Certificate of Appropriateness for 640 W Washington Ave.

May 20, 2019

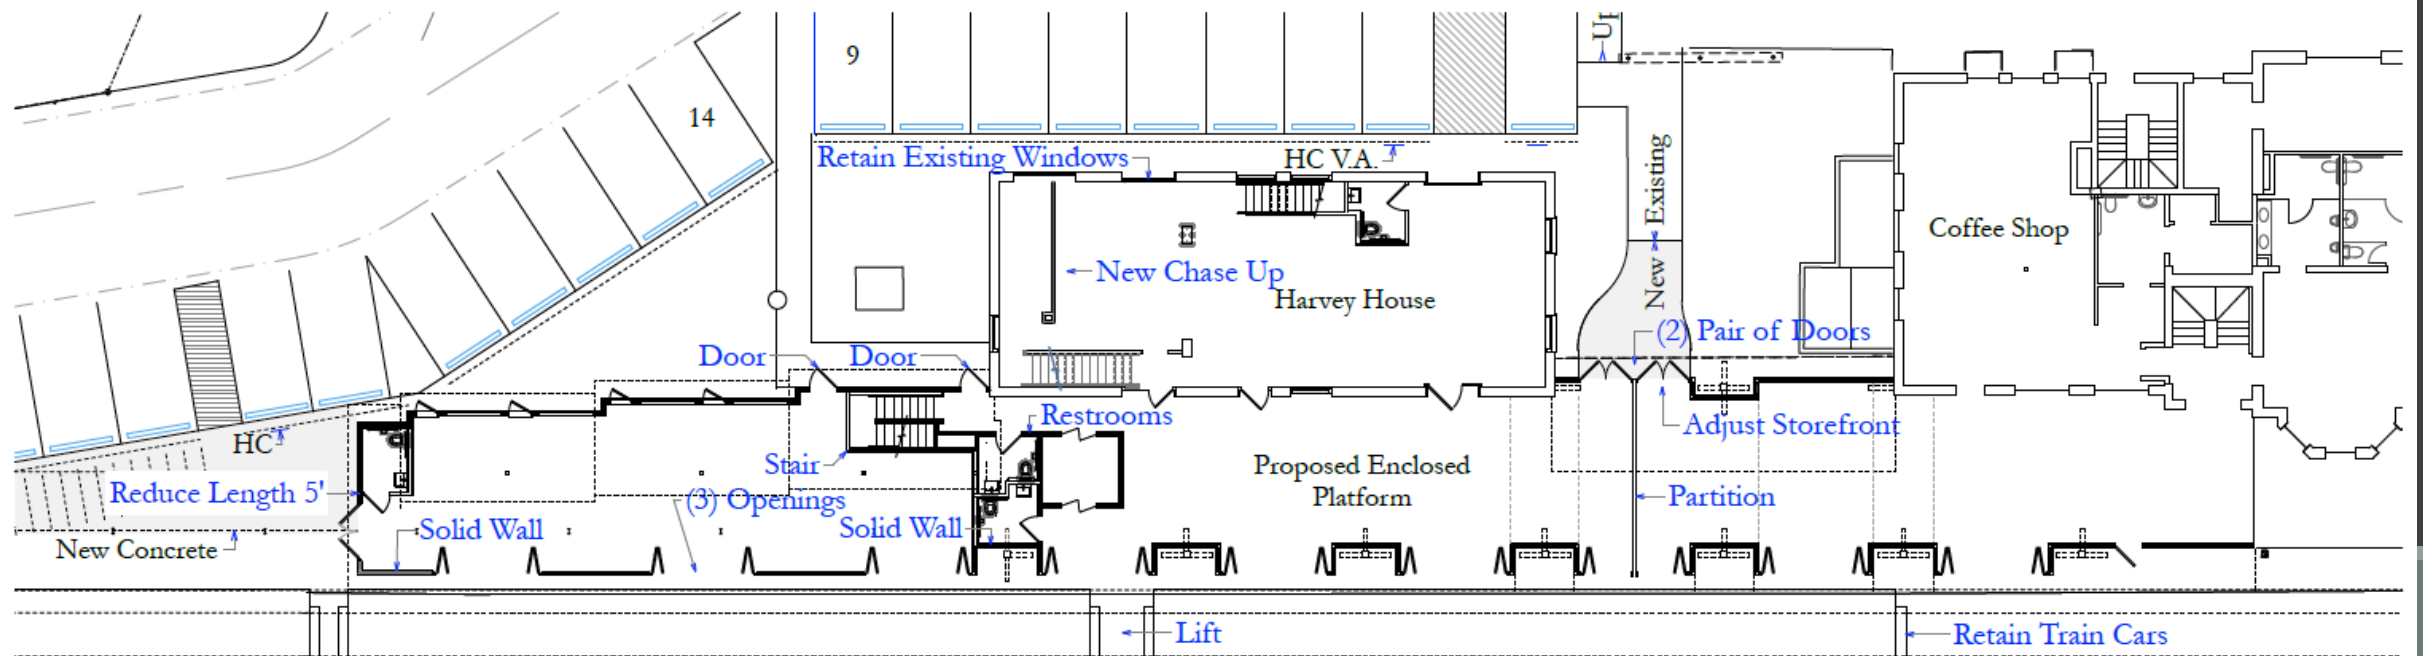
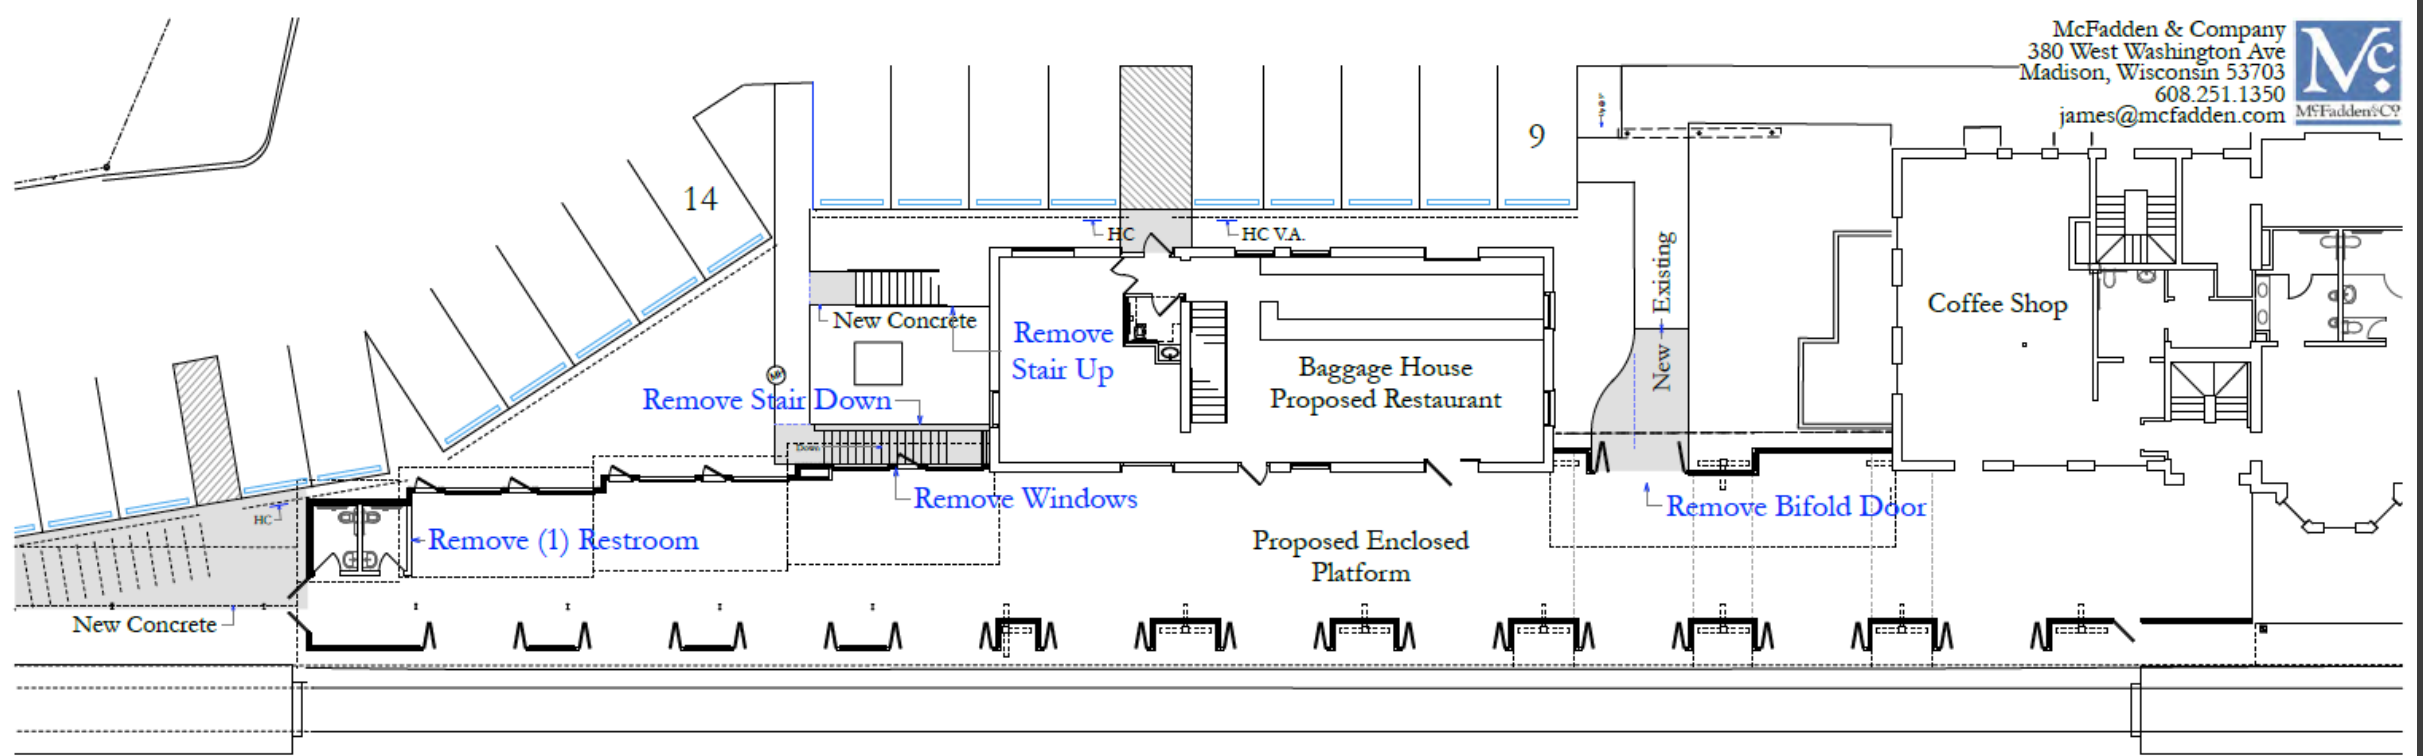
- Renewal of April 2017 COA to enclose former passenger platform
- Alteration to original COA
 - No exterior stair
 - Two solid walls for passenger platform
 - Solid wall dividing interior space rather than just a clear divider

Staff believes that the standards for granting a Certificate of Appropriateness for the exterior alterations of the landmark can be met and recommends that the Landmarks Commission approve the application with the following conditions:

1. The trackside enclosure of the former passenger platform return to the glass enclosure system that Landmarks Commission previously approved.
2. Rather than solid walls serving as partitions between the platform spaces, they be constructed of a material that is either clear or occluded so as to be able to convey light but support privacy between the spaces.
